March 28, 2013

Re: Comments on PG&E's Work Plan on the Response to Investigative Order No. R6V-2012-0060: Byproducts Plume Monitoring in IRZ Areas, Pacific Gas and Electric Company (PG&E), Hinkley Compressor Station, San Bernardino County dated February 15, 2013.

IRP Manager's Draft Comments Regarding PG&E'S Proposed Manganese Monitoring Work Plan¹: Analysis of Proposed Alternatives A and B*

**FIGURE 1A
MONITORING WELL LOCATIONS PER
BOARD ORDER NO. R6V-2012-0060
AND TRACER STUDY LOCATIONS**

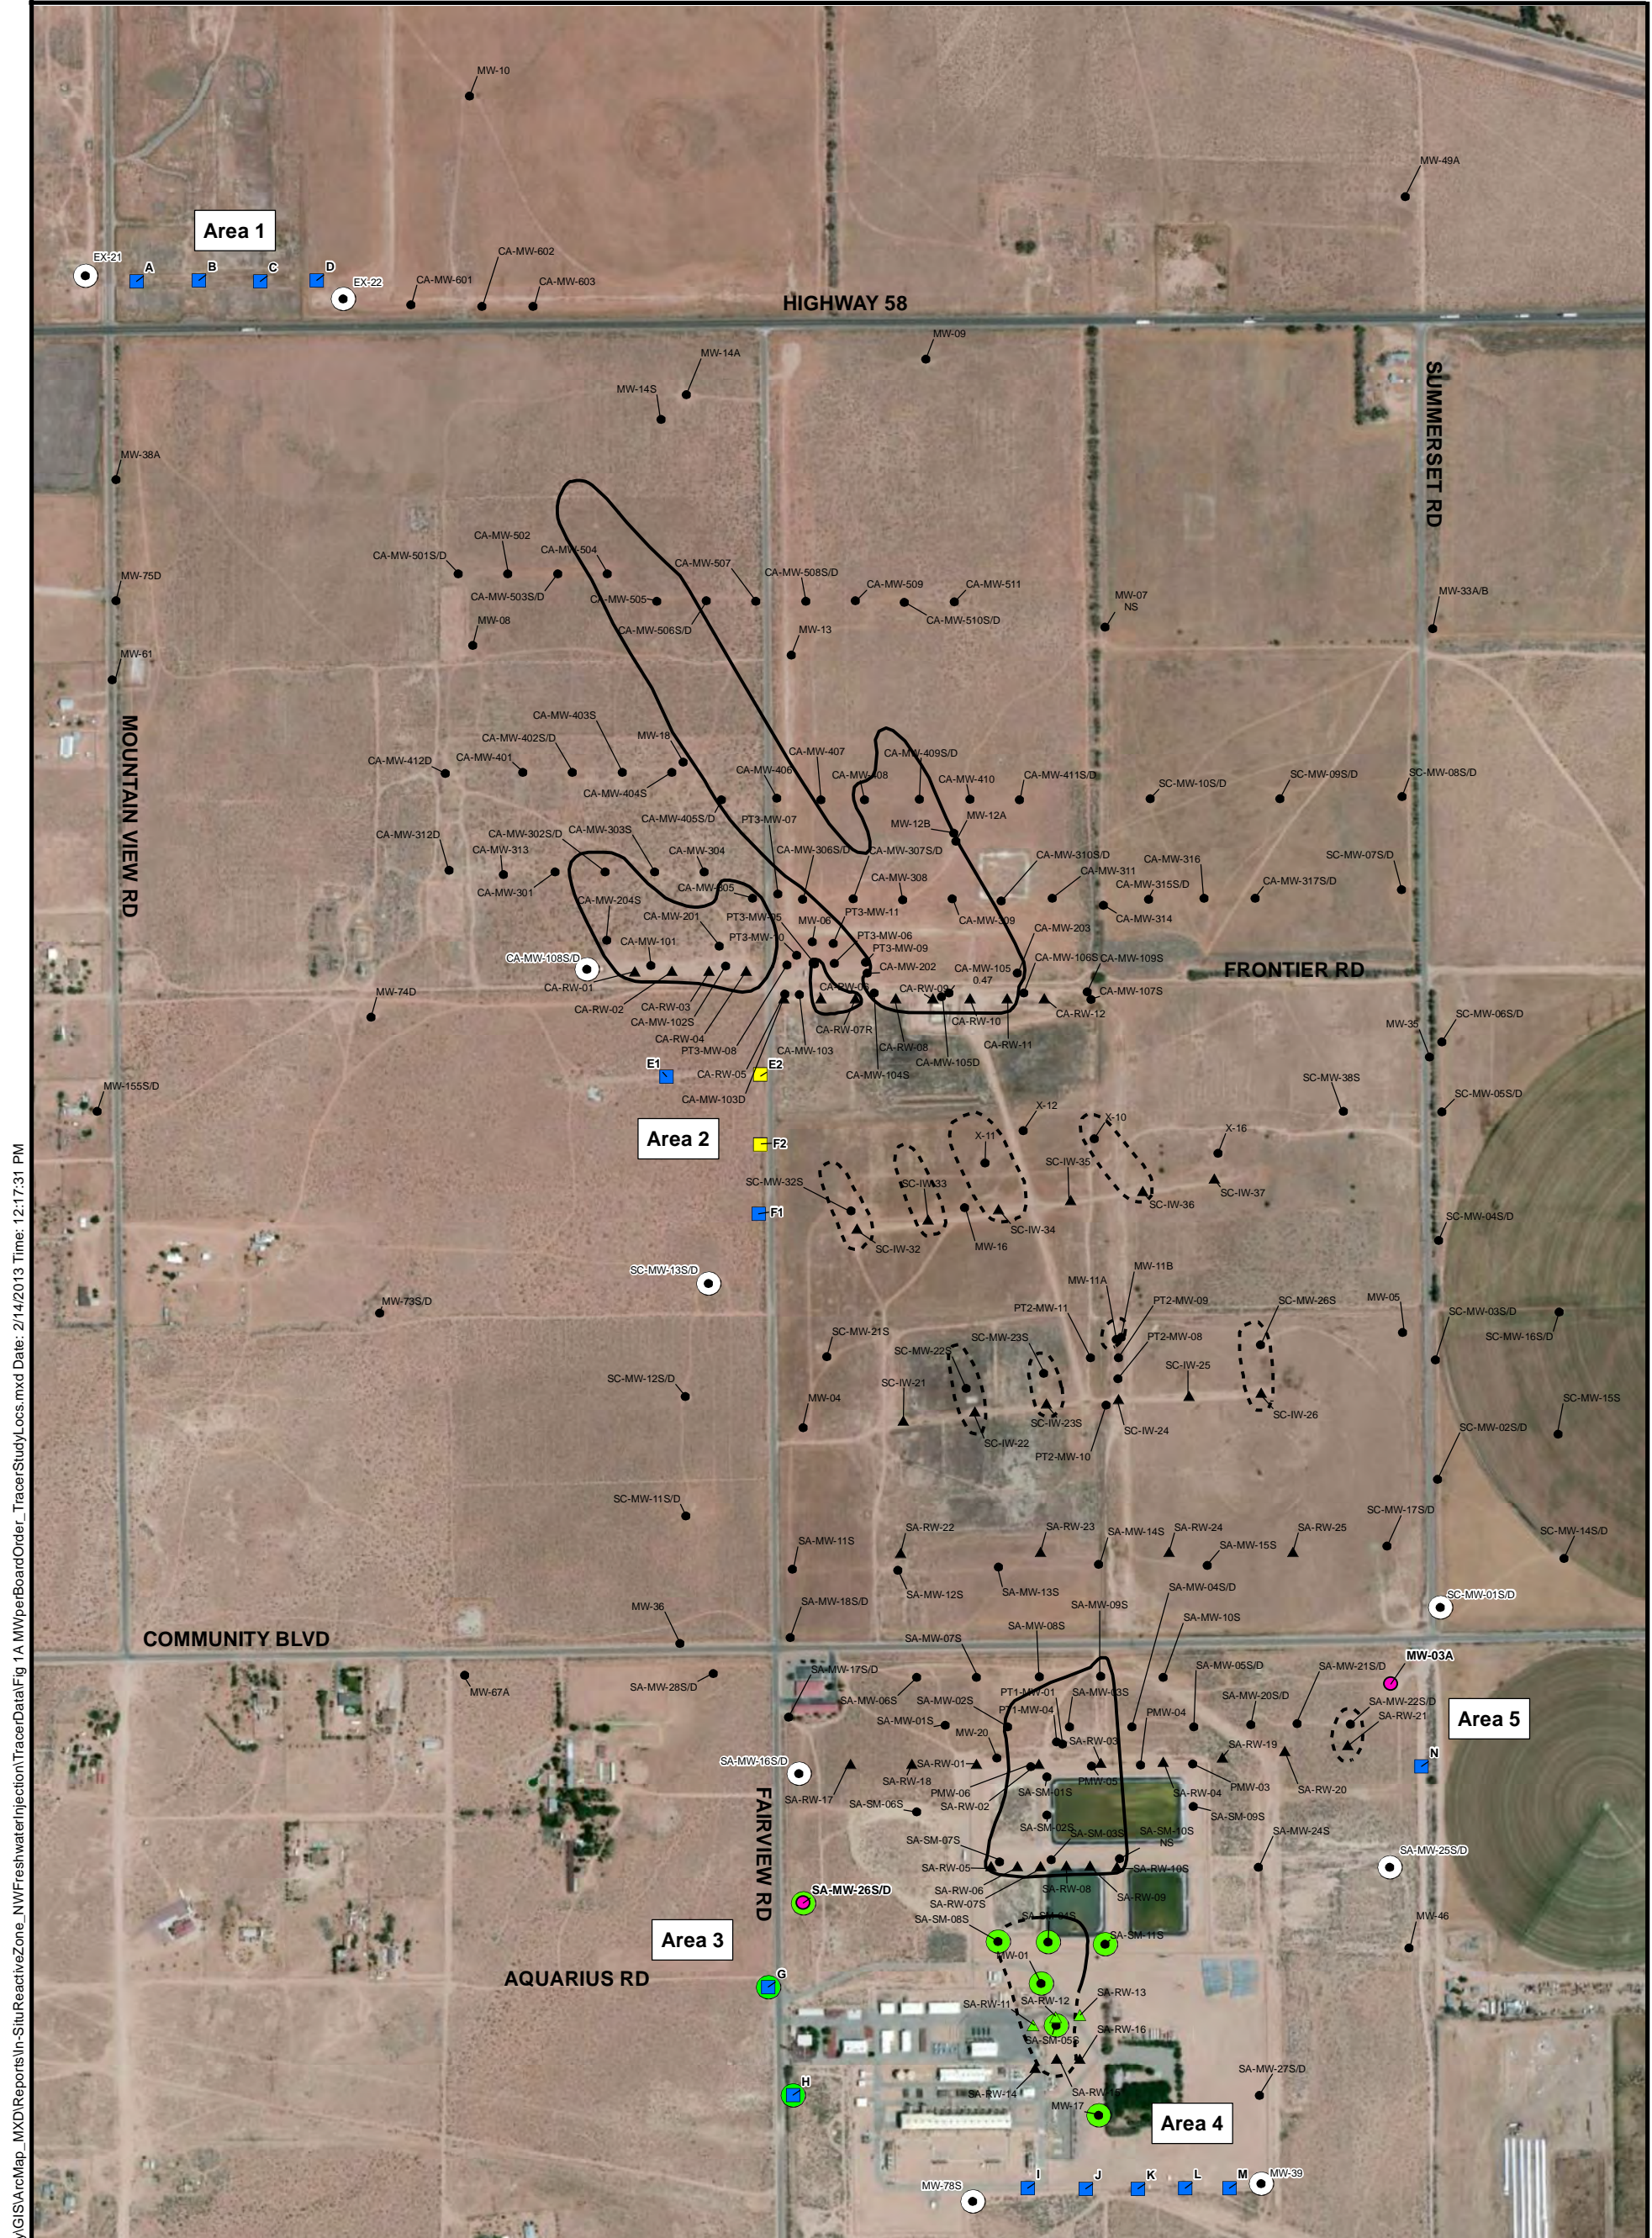
In Alternative B, PG&E is proposing to install Well D approximately 100 ft north of extraction well EX-22. Given known groundwater flow directions, well D may not be in the Manganese groundwater flow pathway, since it is located, and possibly "protected" from measuring any upgradient Manganese groundwater impacts, since it is located downgradient of EX-22. (i.e. there is a possibility that well D could be within the radius of influence of EX-22, and thereby generate Manganese false negatives readings in Area 1. The IRP Manger is recommending that Well D is installed further to the west (or southwest) of EX-22. A discussion on the radius of influence of EX-21 and EX-22 should be included in the Work Plan.

The IRP Manger recommends that Wells E2 and F2 are eliminated from both Alternative A and B since both wells may be within the 390 ppb and above, contoured Manganese plume area. Wells E1 and F1 appear to be better candidate

locations, and the IRP would recommend their locations be moved further west, if possible.

The IRP Manager is in agreement with the proposed locations for Well G and Well H.

Groundwater flow is generally in the northerly direction so the IRP Manager is in agreement that the well configuration sampling layout proposed for Alternative B for Area 4 is appropriate. However, if sampling results at wells MW-17, MW-39, MW-78 and SA-MW-27 are above the threshold of Manganese then the IRP Manager would recommend the installation of Wells I, J, K, L and M.

The IRP Manager is in agreement with the proposed location of Well N.

- It would also be helpful to have the Work Plan's Figures 1A & 1B show the 3.1 ppb Cr6 plume boundary, and the location of the Lockhart Fault.
- * This Table was provided as a "Draft" to the Water Board at the Water Board's "Manganese Investigation Update Community Meeting" held on March 14, 2013 in Hinkley, CA. The IRP Manager learned during the Water Board briefing that some modifications have been made to the work plan (e.g. monitoring well locations and the addition of a 2nd tracer test) subsequent to its submission on February 15, 2013. Many of the modifications are consistent with the above suggestions.

**FIGURE 1B
PG&E PROPOSED MONITORING WELL
AND TRACER STUDY LOCATIONS**

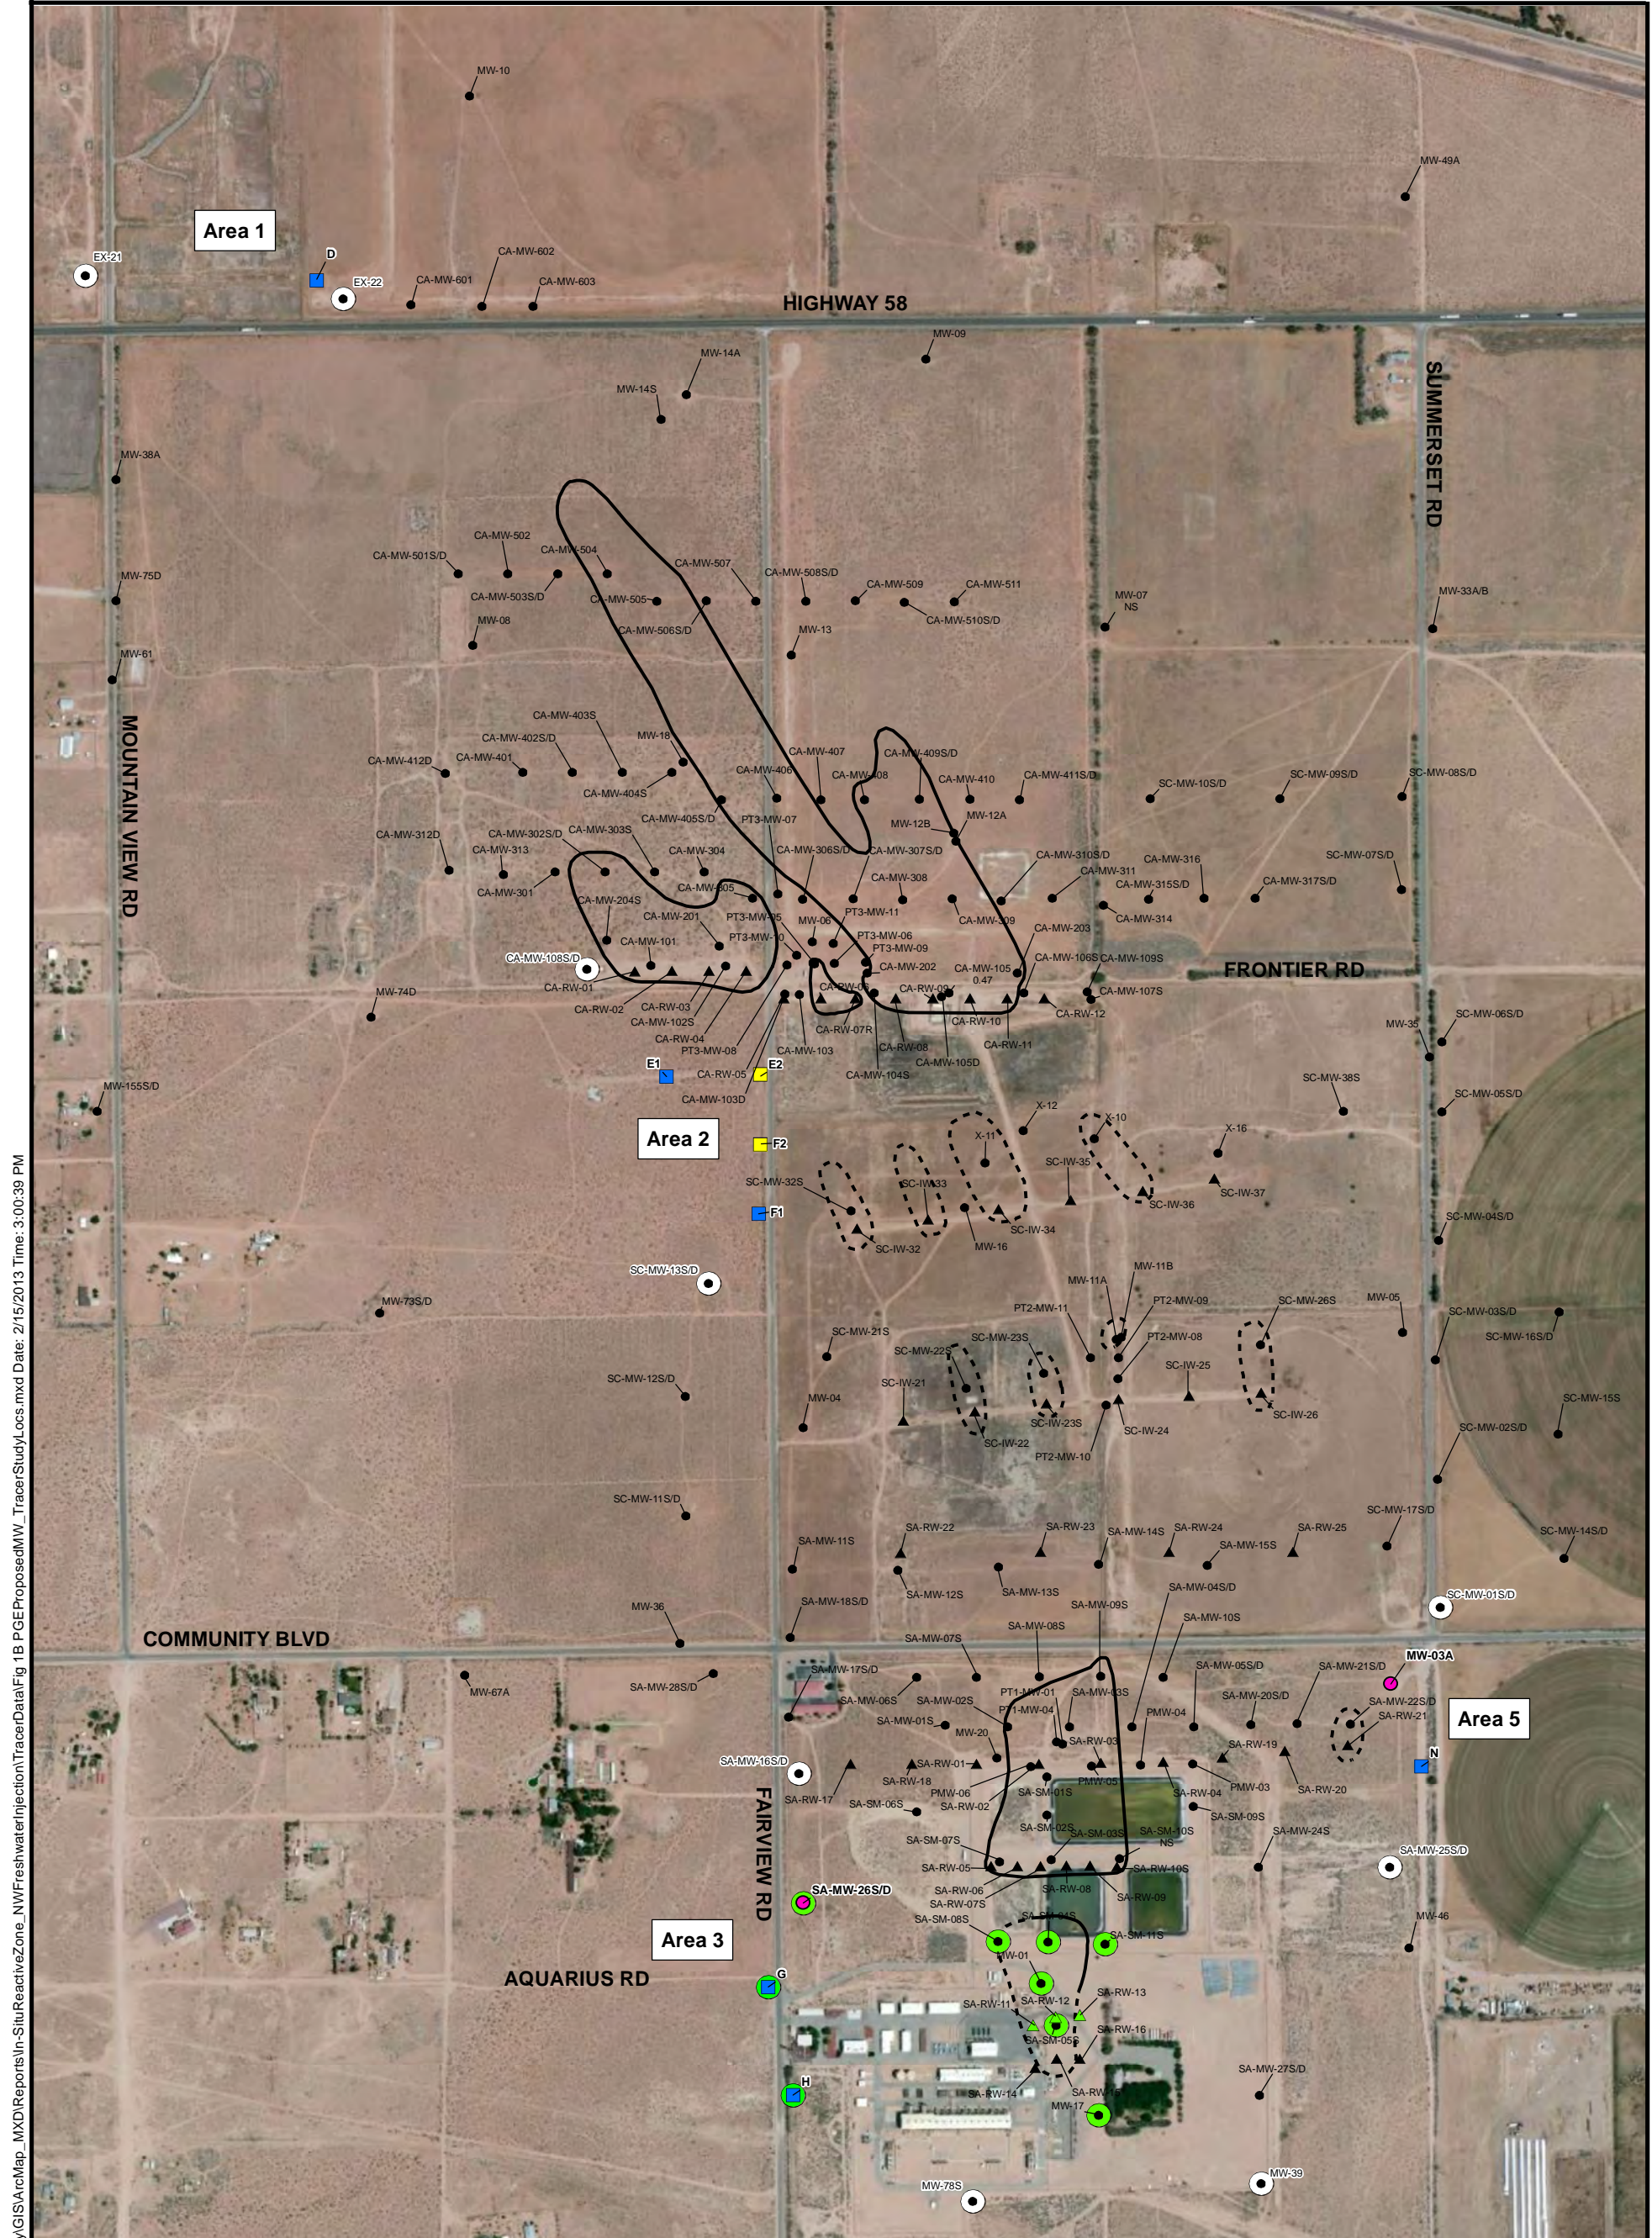
PG&E proposes to inject tracer at six existing wells (SA-RW-11, SA-RW-12, SA-RW-13, SA-RW-14, SA-RW-15 and SA-RW-16). All wells are located within the Source Area IRZ. If we assume a (maximum) groundwater flow rate of 4 feet per day, the furthest that the tracer might travel is ~3,600 ft in the two and half years proposed in the Work Plan; that is, the tracer might reach the Central IRZ Area. The IRP Manager therefore recommends expediting the study by injecting another tracer simultaneously at another location; namely northwest injection well (CA-RW-01) or near Highway 58.

Figure 1A from PG&E's Manganese Monitoring Work Plan of 2/15/13

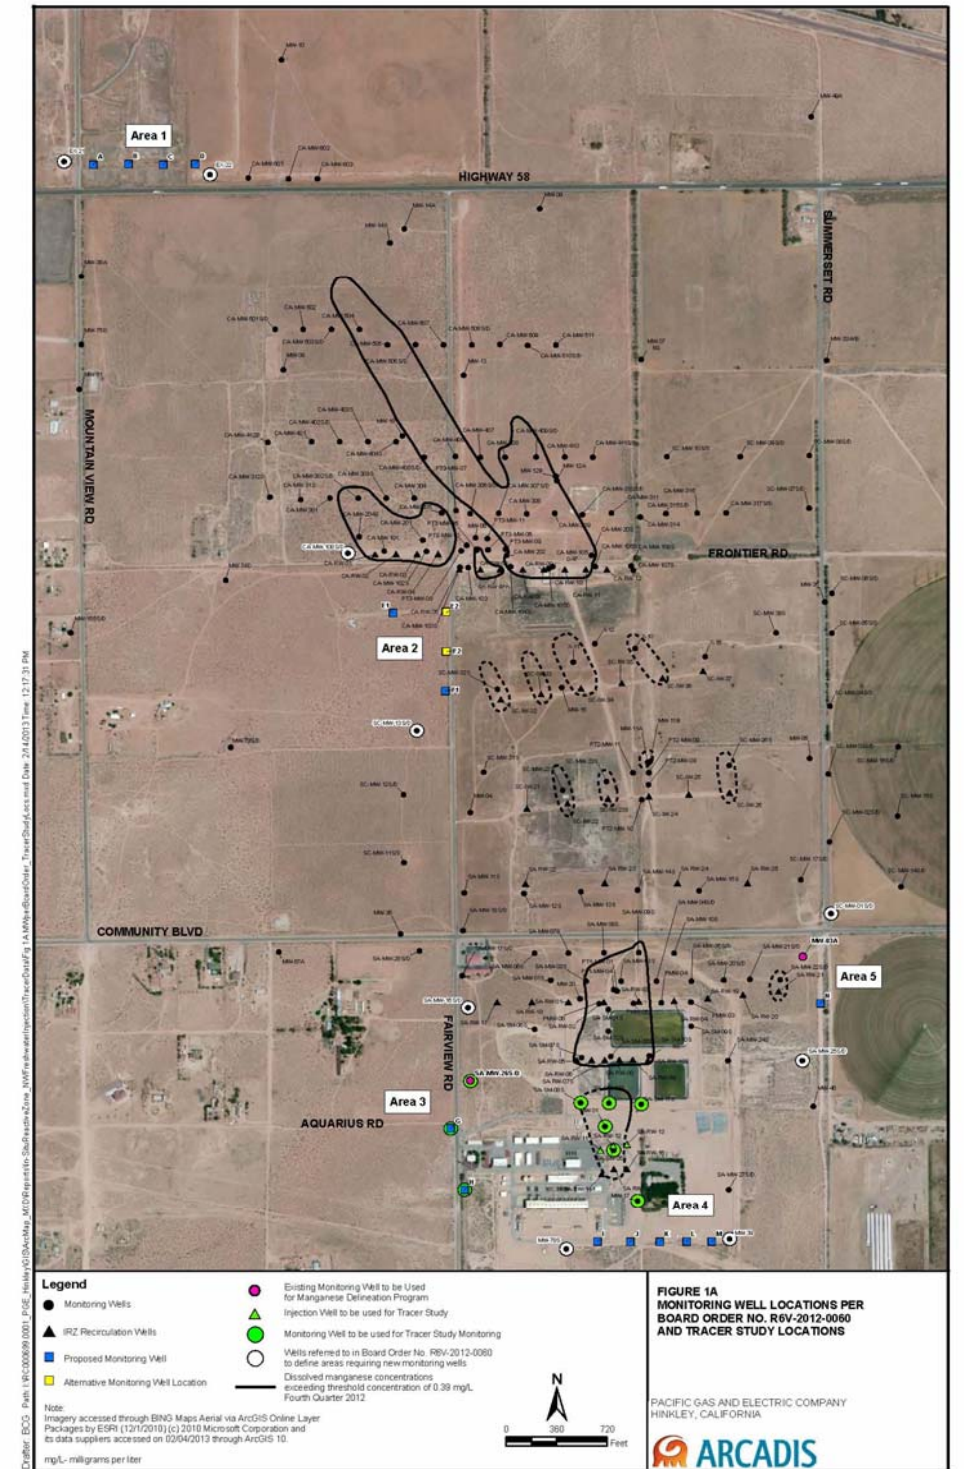
Area 1	Area 2	Area 3	Area 4	Area 5
Compliance Plan with IO³ No.R6V-2012-0060 (Plan A)	4 Wells between EX-21 and EX-22: Wells A through D	2 Wells: E1 and F1 (Note: Two alternatives are shown as E2 and F2)	2 Wells : G and H	5 Wells: I, J, K, L and M	1 Well: N
PG&E Proposed Plan (Plan B)	1 well between EX-21 and EX-22: Well D	Same as Above	Same As Above	No Wells	Same As Above
Difference Between Plans	Plan B does not include wells A, B, and C	None	None	Plan B does not include any new (upgradient) wells	None
IRP Manager Area Specific Comments⁴	Plan A: Recommend that all wells in Plan A should be installed slightly south of proposed locations to ensure that wells are not in the radius of influence of EX-21 and EX-22. Plan B: Recommend well D should be located further to this southwest to avoid any false negative readings because the possible influence of EX-22.	Recommend that alternative wells E2 and F2 be eliminated since they might be within the manganese 390 ppb plume boundary. E1 and F1 should be located slightly further west if possible to avoid the manganese 390 ppb plume ⁵ .	Agree with Work Plan.	Agree with Alternative B	Agree with Work Plan

IRP Manager Tracer Comments	The tracer study is planned for the southern area of the plume bounded by Areas 3, 4 and 5. Given that the western boundary of the 3.1 ppb Cr6 plume runs close to the proposed tracer study monitoring well, SA-MW-26 S/D, G and H, we recommend that another monitoring well be located further to the west of Fairview Rd and north of Aquarius Rd. It is important that any possibilities of western migration be examined, since the entire manganese issue initially arose from complaints about "black water" to the west defined plume. Also we recommend that the need for tracer study work should be discussed at the locations of the manganese impacts north of Frontier Rd. and south of Highway 58. We do acknowledge that there are, now, a lack of residences in this area.
